# Environmental Impact Analysis Process

nal Environmental Impact Statement

Volume II

High Frequency Active Aurora

FIGURE 12.12-1. TYPICAL LINE-OF-SIGHT VIEWING ABILITY FROM THE TOK CUT-OFF.

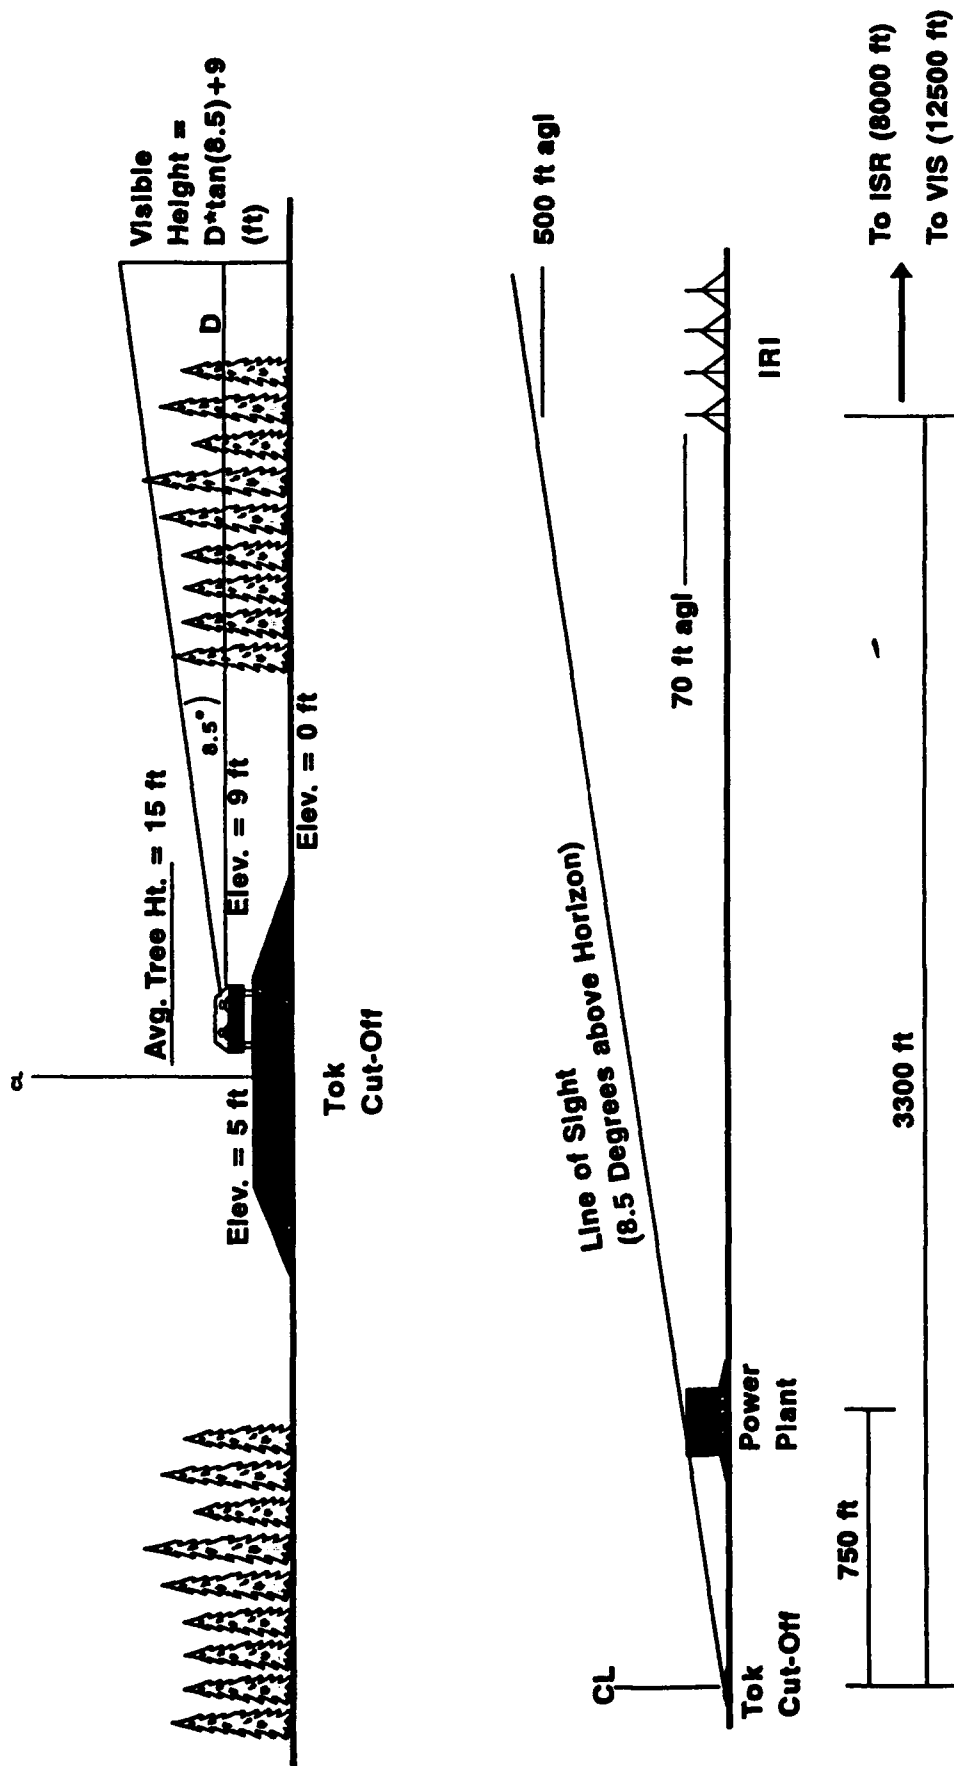
**Q. Can you address alternatives to placing the antenna array in its proposed location so it does not detract from a possible scenic byway designation for the Tok Cut-Off.**

**A.** Below is a simplified cross-section of the HAARP facilities at the Gakona site (Figure 12.12-1). The large power plant/operations center building is visible from the road, only because of the clearing that has been formed by the access road. Were it not for the existing access road, the power plant would be barely visible from the Tok Cut-Off. The power plant building is about 750 feet from the road and currently is about 70 feet in height. Trees in the Gakona site region vary widely in height (8 to 25 feet) and average about 15 feet, and the forest is typically medium density conifer stands (spruce) with intermixed small clearings and deciduous groves. Examination of aerial photographs shows that most of the area along the Tok Cut-Off is wooded and views are obstructed by the vegetation along the sides of the road right-of-way.
